UNITED STATES PATENT AND TRADEMARK OFFICE

APPLICATION NO.	FILING DATE	FIRST NAMED INVENTOR	ATTORNEY DOCKET NO.	CONFIRMATION NO.
10/600,208	06/19/2003	Darko Segota	11023.6	9025

Office Action Summary	Application No. 10/600,208	Applicant(s) SEGOTA ET AL.	
	Examiner William H. Rodriguez	Art Unit 3746

DETAILED ACTION

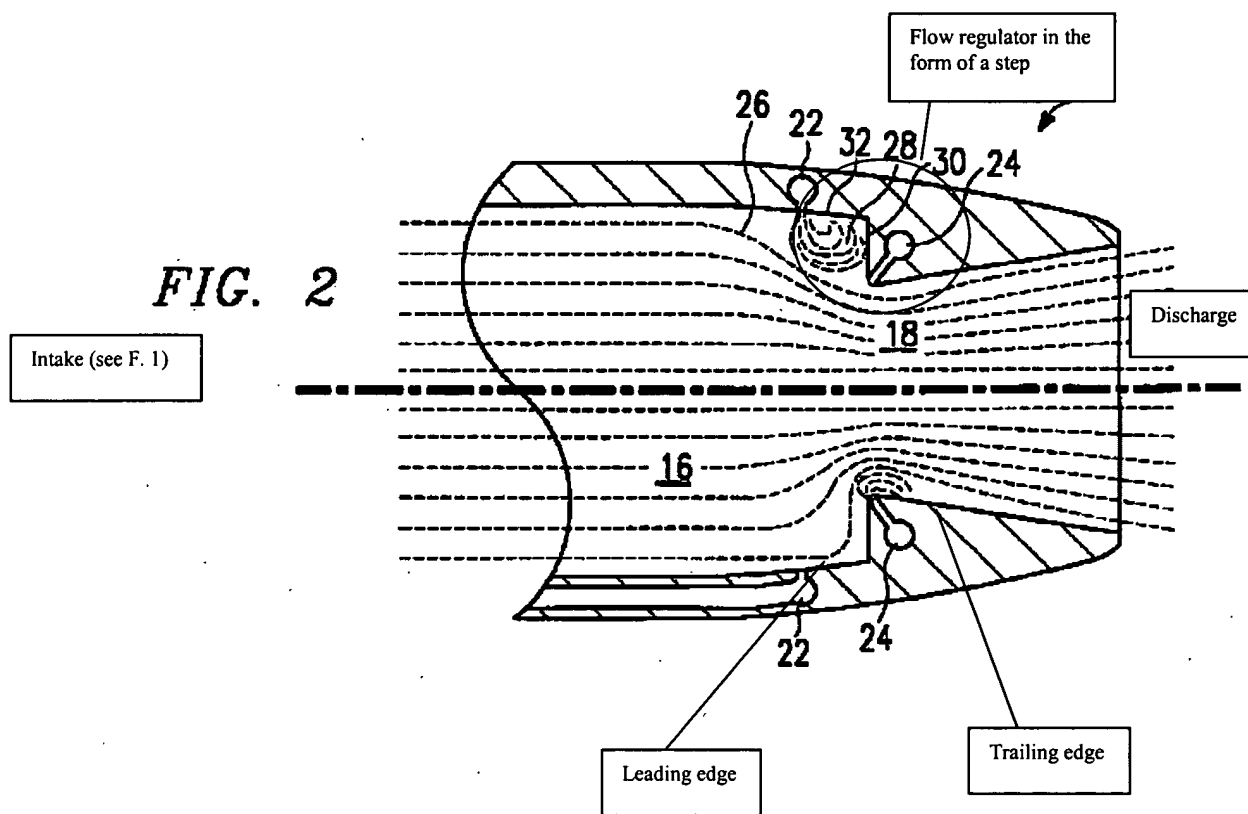
5. Claims 31-34 are rejected under 35 U.S.C. 102(b) as being anticipated by **Terrier (US 5,664,415)**.

Terrier teaches an apparatus comprising: an intake, a discharge, and a flow regulator in the form of a step, said step extending between a leading edge and a trailing edge. See particularly Figures 1 and 2.

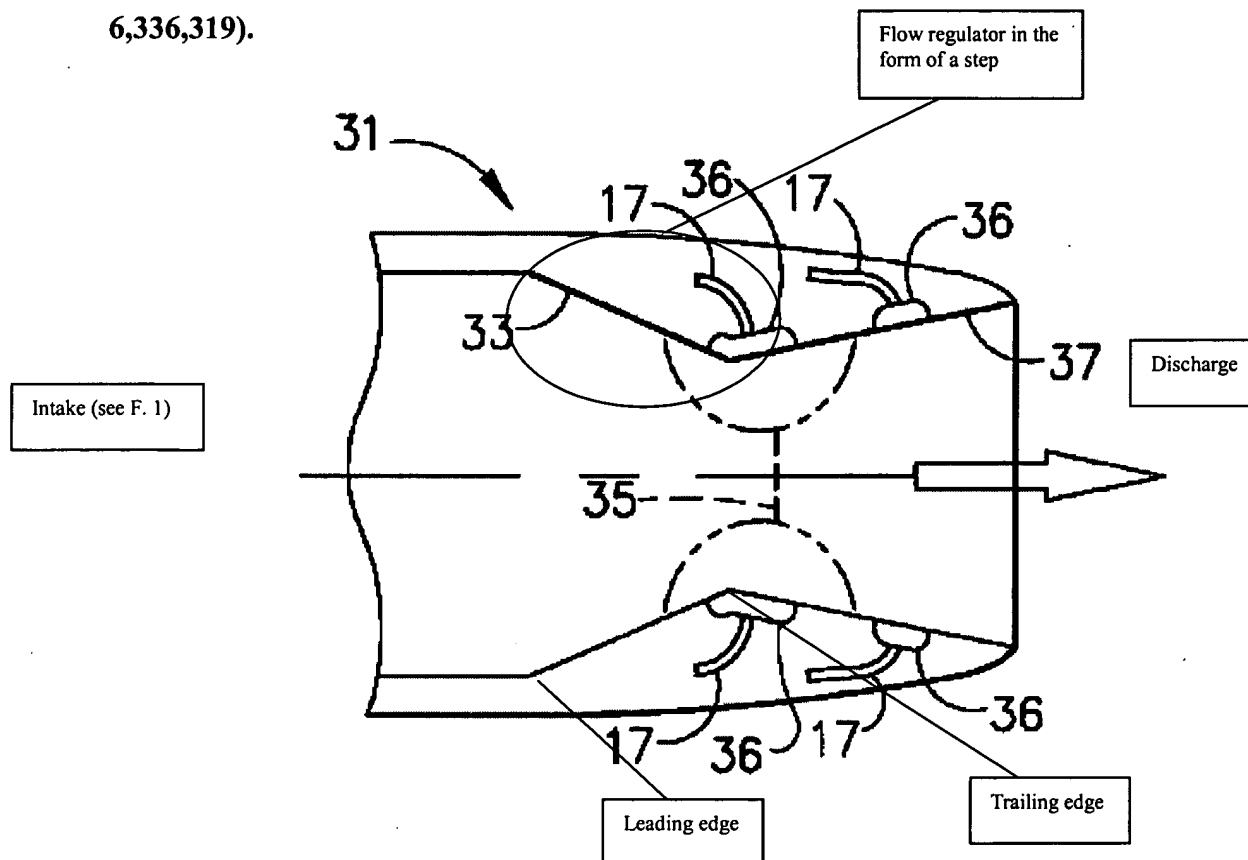
6. Claims 31-34 are rejected under 35 U.S.C. 102(b) as being anticipated by **Koshoffer** (US 6,336,319).

Koshoffer teaches an apparatus comprising: an intake, a discharge, and a flow regulator in the form of a step, said step extending between a leading edge and a trailing edge. See particularly Figure 3.

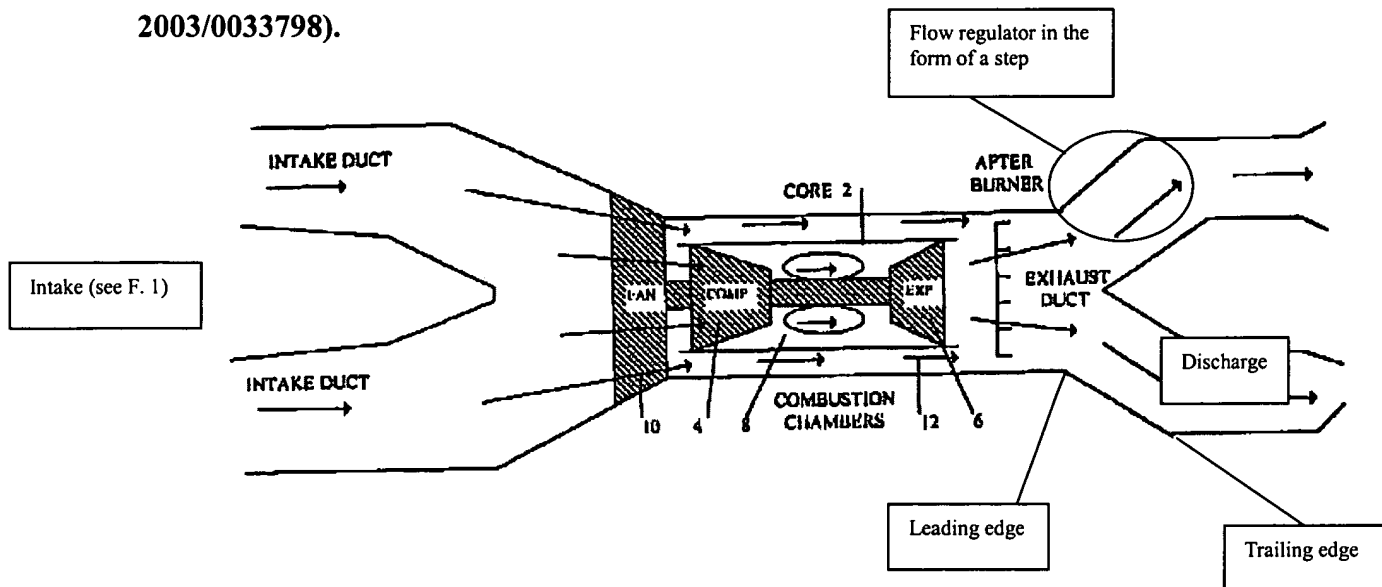
7. Claims 31-34 are rejected under 35 U.S.C. 102(e) as being anticipated by Dickau (US 2003/0033798).

Dickau teaches an apparatus comprising: an intake, a discharge, and a flow regulator in the form of a step, said step extending between a leading edge and a trailing edge. See particularly Figure 1.
